SUBJECT: WATTS BAR NUCLEAR PLANT - REQUEST FOR ADDITIONAL
INFORMATION (RAI) REGARDING TRITIUM PRODUCTION - INTERFACE ISSUE
NUMBER 2 - PROCUREMENT AND FABRICATION ISSUES (TAC NO. MB1884)

The purpose of this letter is to provide information regarding
NUREG1672, Interface Issue Number 2, "Procurement and Fabrication
Issues," that was requested to be docketed by NRC Project Manager,
Mark Padovan.

ENCLOSURE 1
TENNESSEE VALLEY AUTHORITY
WATTS NUCLEAR PLANT (WBN)
UNIT 1
DOCKET NO. 390
INTERFACE ITEM NUMBER 2
PROCUREMENT AND FABRICATION ISSUES

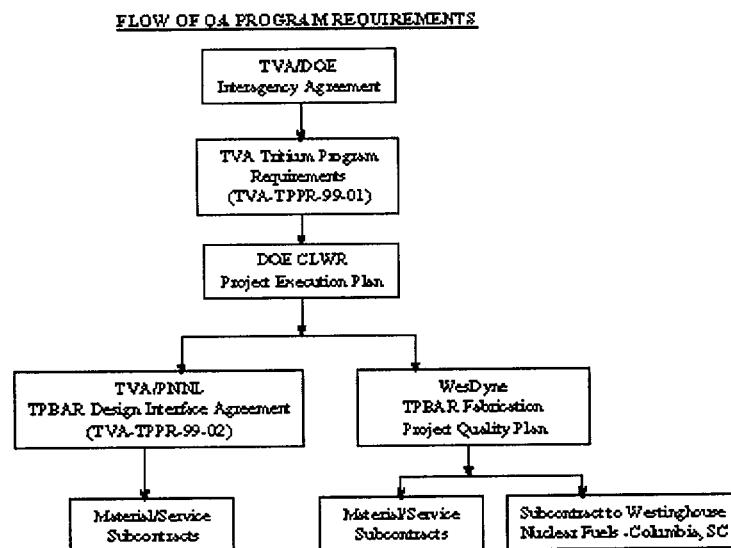
NRC needs "evidentiary material" from TVA that the manufacturers of the tritium assemblies (including subcontracted components/subassemblies) have quality assurance programs that comply with Appendix B requirements. Please discuss how TVA imposes QA requirements on the suppliers (probably through the procurement documents) and provide evidence of same. Also, please provide assurance that the suppliers have adequately implemented QA programs in conformance with Appendix B. (Is this accomplished through NUPIC audits or, for the special case of tritium, through supplier audits TVA conducts?). Please send us the audit reports and supplementing information which would support a conclusion that the suppliers have established and implemented QA programs in conformance with Appendix B requirements. Supplementary information might include supplier exceptions to TVA QA program or additional commitments to national standards by the supplier, which go beyond TVA's QA program in areas such as subcontracting, design, or manufacturing.

TVA Response: (Note: Some enclosures only contain excerpts from referenced documents) TVA has no direct procurement document with any of the material, service, or component suppliers of TPBARs. TVA has an Interagency Agreement with the Department of Energy (DOE) (Enclosure 2) that requires DOE to flow down TVA requirements to suppliers and which requires the major DOE direct suppliers to be on the TVA acceptable supplier list (ASL). The TVA technical, functional, and quality requirements for the design, procurement, and fabrication of TPBARs are contained in a TVA Tritium Production Program Requirements Document (TVA-TPPR-99-01) (Enclosure 3). There are currently two DOE direct suppliers involved in the supply of TPBARs. The Pacific Northwest National Laboratory (PNNL), a DOE owned site operated by the Battelle Memorial Institute, performs TPBAR design and procurement activities. WesDyne International LLC performs procurement and fabrication activities. Both of these suppliers are on the TVA ASL for their respective current scopes of work.

DOE identifies the TVA requirements to project participants in section 5.2.1 of the CLWR Project Execution Plan (Enclosure 4). Evidence of project participant implementation of the TVA requirements is demonstrated through a TPBAR Design Interface Agreement between TVA and PNNL (Enclosure 5) and the WesDyne Project Quality Plan for TPBAR Fabrication (Enclosure 6). Sub-suppliers are required to meet the applicable QA program requirements as determined by the procuring organization (i.e. PNNL or WesDyne). The DOE direct suppliers have been audited by TVA to ensure compliance with Appendix B requirements. PNNL was initially placed on the TVA ASL under the Lead Test Assembly Project and maintained on the ASL through annual evaluations and triennial audits (Enclosure 7). WesDyne was recently placed on the TVA ASL after completion of an initial qualification audit (Enclosure 7).

The following diagram depicts a summary view of the flow of QA program requirements.
